SUNDRY NOTICES AND REPORTS ON WELLS

Do not use this form for proposals to drill or to re-enter an abandoned well. Use Form 3160-3 (APD) for such proposals.			6. If Indian, Allottee or Tribe Name	
SUBMIT IN TR	7. If Unit or CA/Agreement, Name and/or No. Poker Lake Unit NMNM 71016X 8. Well Name and No. Poker Lake Unit 339H

BOPCO L.P. respectfully request to ammend point four of the 8pt drilling program from the original APD that was approved on 08/24/12. Point four of the drilling program will now read as stated in the attached page. The subsequent diagrams are also attached.

POINT 4: PRESSURE CONTROL EQUIPMENT (SEE ATTACHED DIAGRAM 2)

13-5/8" X 3-M BOPE (2 Rams and Rotating Head) & Closed Loop System Equipment Schematic Diagram 2

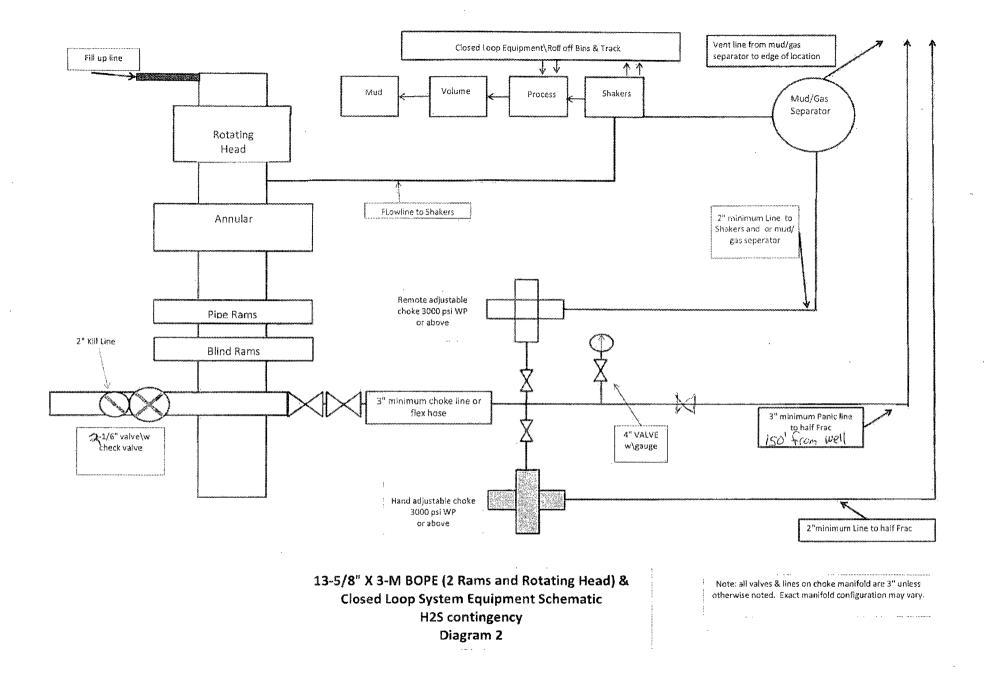
After running the 13-3/8" surface casing, a 13-5/8" BOP/BOPE system with a minimum rating of 3M will be installed, used, maintained and tested as per Onshore Order 2. In addition to the high pressure test, a low pressure (250-300 psig) test will be performed.

After running the 9-5/8" intermediate casing, a 13-5/8" or 11" BOP/BOPE system with a minimum rating of 3M will be installed on the 9-5/8" intermediate casing spool (8-3/4" open hole), used, maintained and tested as per Onshore Order 2. In addition to the high pressure test, a low pressure (250-300 psig) test will be performed.

After running the 7" intermediate casing, a 13-5/8" or 11" BOP/BOPE system with a minimum rating of 3M will be installed on the 9-5/8" intermediate casing spool (8-3/4" open hole), used, maintained and tested as per Onshore Order 2. In addition to the high pressure test, a low pressure (250-300 psig) test will be performed.

BOPCO, L.P. would like to request a variance to use an armored, 3", 5000 psi WP flex hose for the choke line in the drilling of the well if the rig is equip with hose. (See specification for hose that might be used, attached with APD exhibits). This is rig equipment and will help quicken nipple up time thus saving money without a safety problem. The hose itself is rated to 5000 psi, and has 5000 psi flanges on each end. This well is to be drilled to 14,148 MD (7,931' TVD) and max surface pressure should be +/- 1966 psi as prescribed in onshore order #2 shown as max BHP minus 0.22 psi/ft. Thus, 3000 psi BOPE is all that is needed for this well. Please refer to diagram 2 for choke manifold and closed loop system layout. If an armored flex hose is utilized, the company man will have all of the proper certified paper work for that hose available on location.

Variance approved to use flex line from BOP to choke manifold. Check condition of flexible line from BOP to choke manifold, replace if exterior is damaged or if line fails test. Line to be as straight as possible with no hard bends and is to be anchored according to Manufacturer's requirements. The flexible hose can be exchanged with a hose of equal size and equal or greater pressure rating. Anchor requirements, specification sheet and hydrostatic pressure test certification matching the hose in service, to be onsite for review. If the BLM inspector questions the straightness of the hose, a BLM engineer will be contacted and will review in the field or via picture supplied by inspector to determine if changes are required (operator shall expect delays if this occurs).
